16 May 2022

**Reference: Campsie Car Parking Strategy**

Reference: Campsie Car Parking Strategy

Figure 2: Draft Campsie Master Plan – Area to which Parking Rates would apply

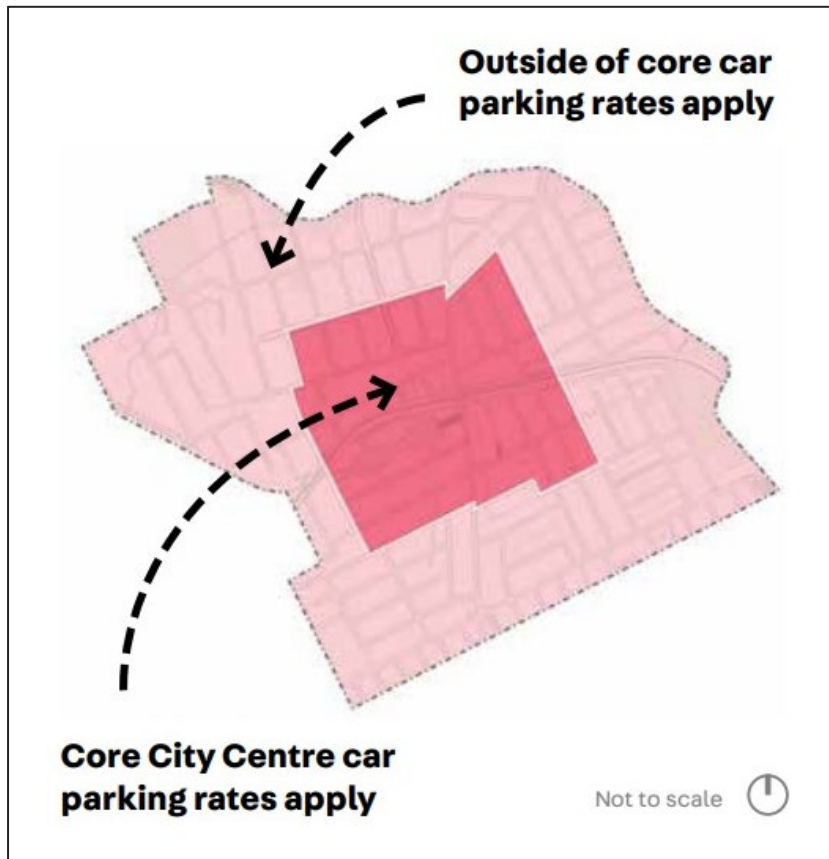
The adoption of the 'beyond core city centre' rates outside of the B4 Mixed Use Zone therefore provides a level of comfort to Council and existing residents that dwellings will have an obligation to provide at least some on-site residential parking. From a developer perspective, a level of flexibility is still retained in the proposed 'beyond core city centre' rates to provide car parking in line with expected levels of demand.

On the basis of the above the proposed modifications as recommended by Council to constrain the area of 'no minimum parking' for Campsie to just the B4 Mixed Use Zone could be supported.

While accepting that an alteration to the area to which the rates apply could be made, it must also be recognised that the change could result in a number of less desirable impacts (when compared with the original proposal) including:

As such it would be recommended that the adoption of a reduced area of 'no minimum parking' rates be considered as part of a staged progression that may ultimately be extended in future years to include residential zones within 400m of the Campsie Station at such time when on-street parking controls are expanded.

- The proposed modifications as recommended by Council to constrain the area of 'no minimum parking' for Campsie to just the B4 Mixed Use Zone could be supported.
- However, this change should be considered as part of a staged progression that may ultimately be extended in future years to include residential zones within 400m of the Campsie Station.
